CITY PLAN COMMISSION STAFF REPORT

Project Name Jay Wolfe Toyota Expansion

CD-CPC-2025-00058

Major Amendment to a Development Plan

1.1 – PRELIMINARY LANDSCAPE PLAN 1.2 – TREE SURVEY

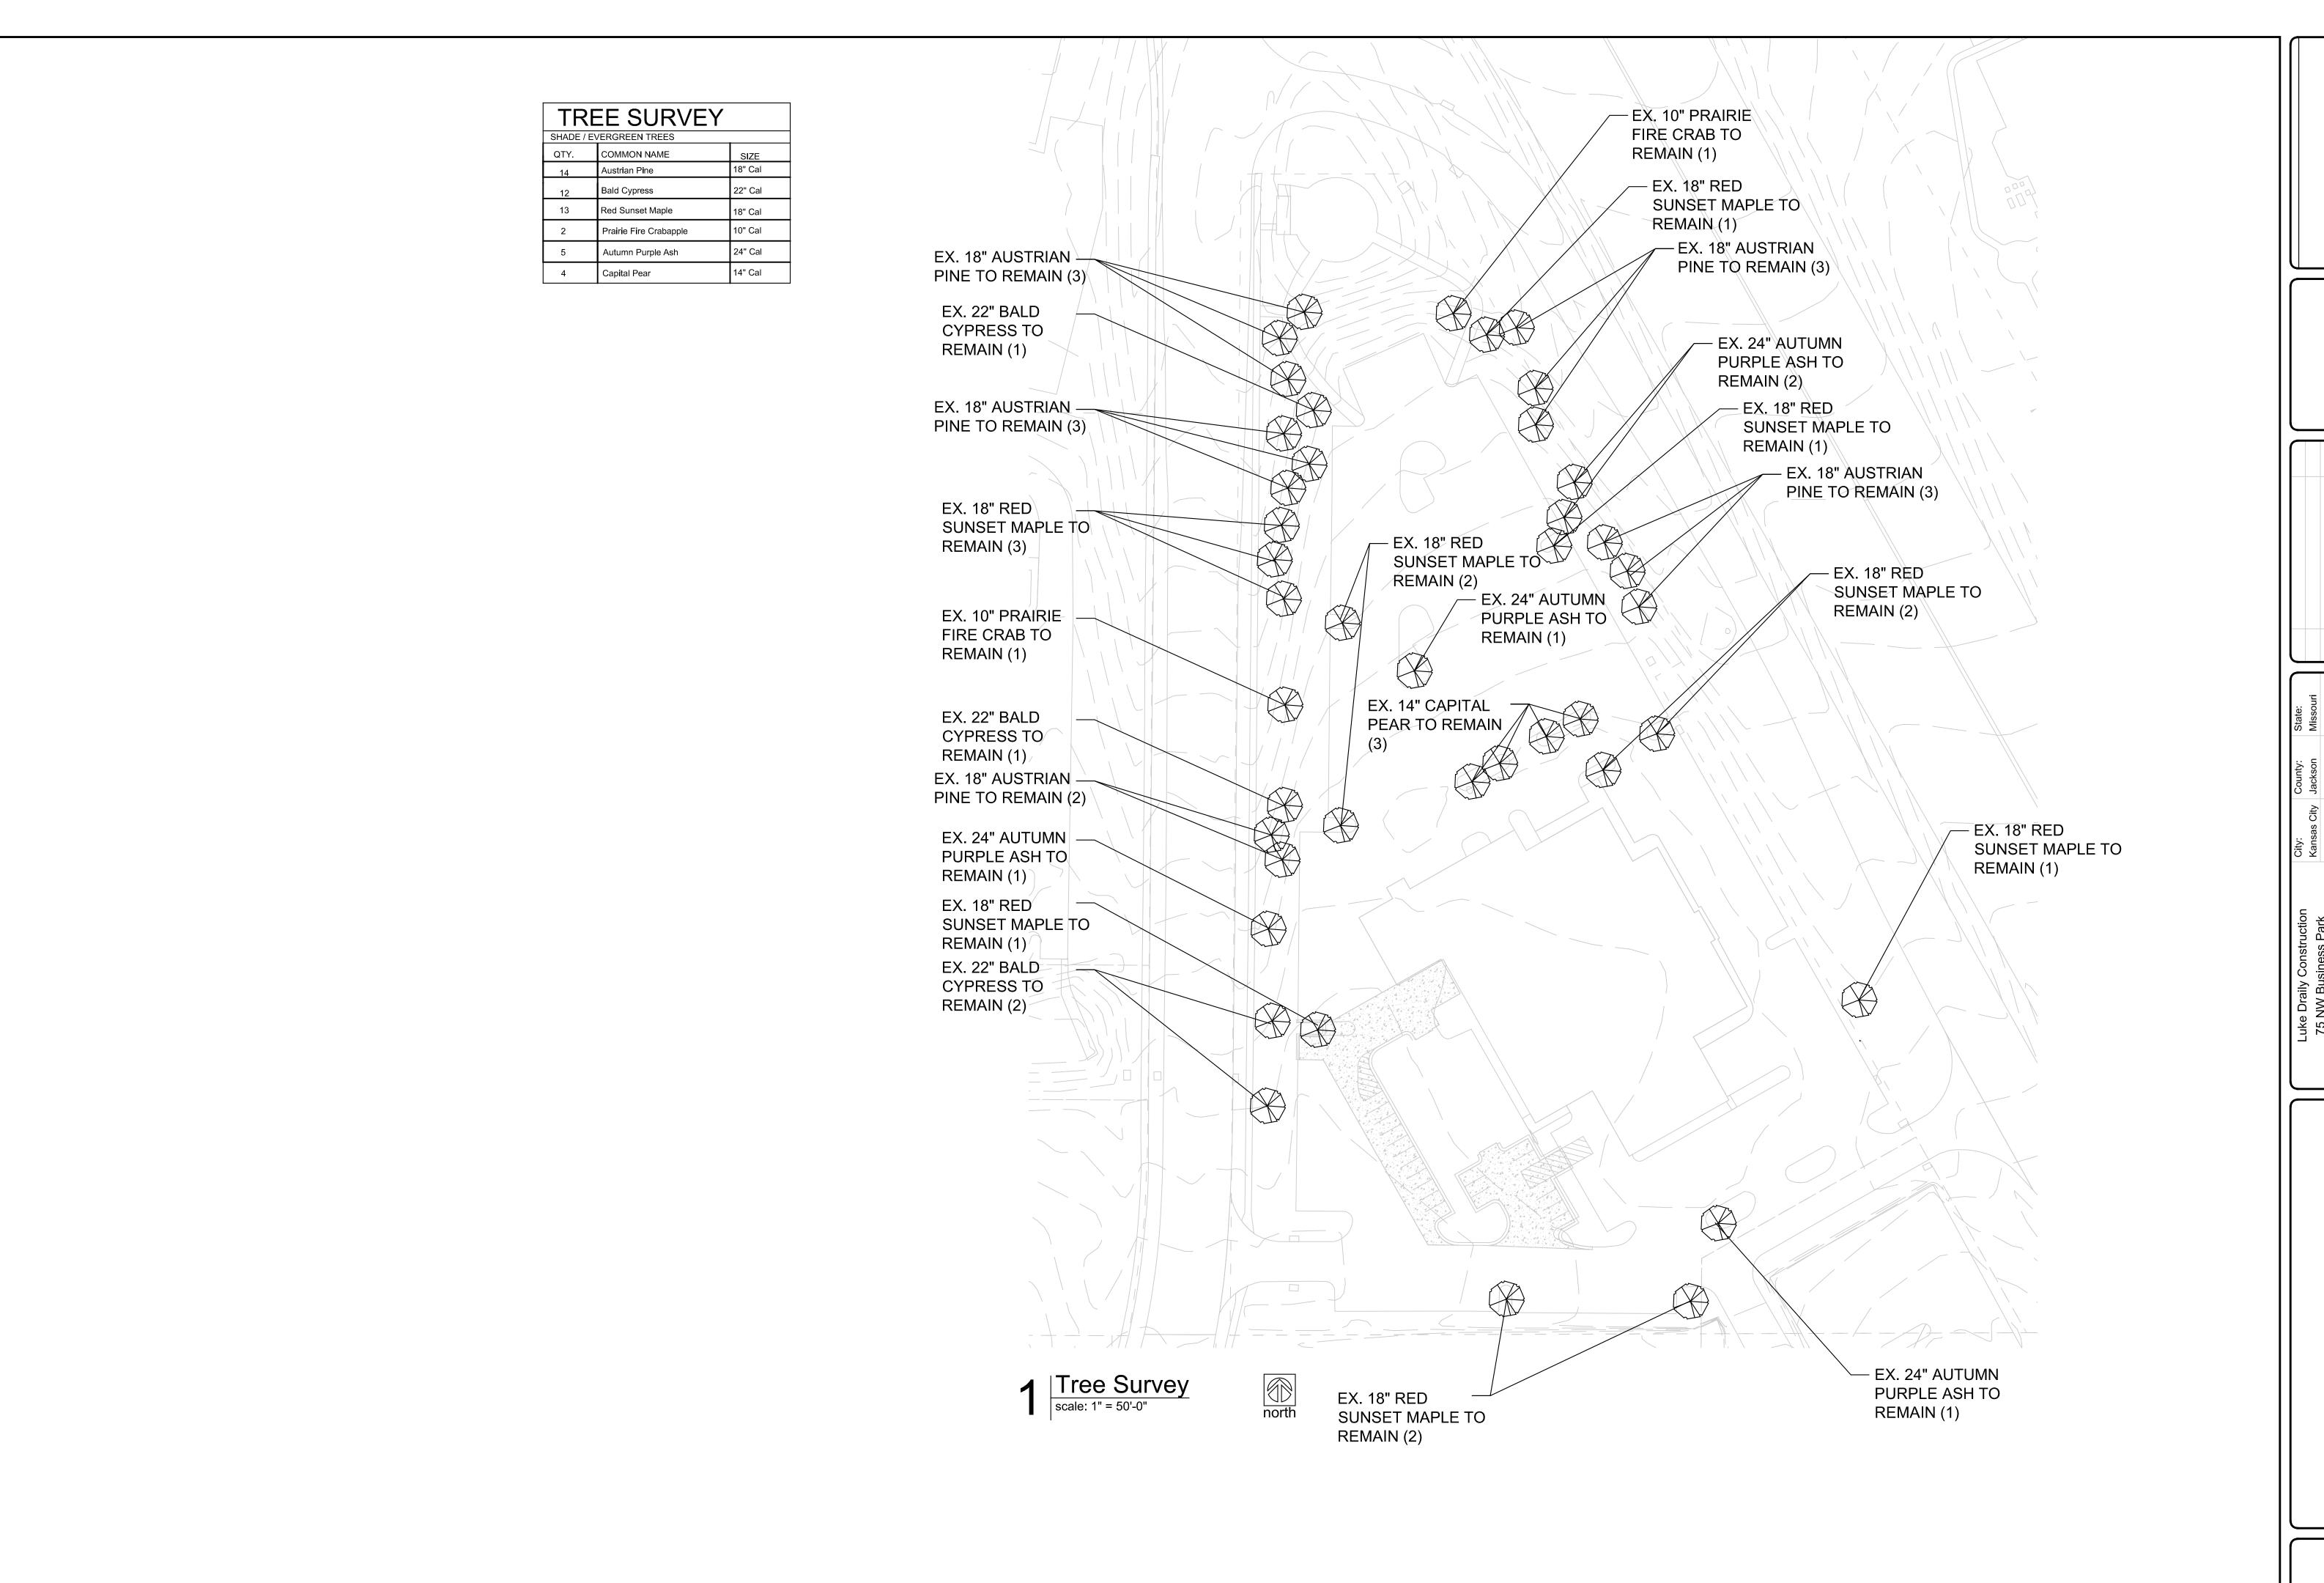
better meet the "well-designed city" goal, enhanced landscaping along the eastern side of the site is recommended as I-29 is designated as a primary image street by the KCI area plan." - Alexis Berra

Evaluation	Goal	Notes
High	SEG	SEG: Project utilizes existing infrastructure
Medium		WDC: Project does not provide enhanced landscaping along primary image street
Low

The proposed project helps advance some of the KC Spirit playbook and KCI Area Plan goals. The proposed addition matches the "commercial" future land use designated by the KCI area plan. To better meet the "well-designed city" goal, enhanced landscaping along the eastern side of the site is recommended as I-29 is designated as a primary image street by the KCI area plan.
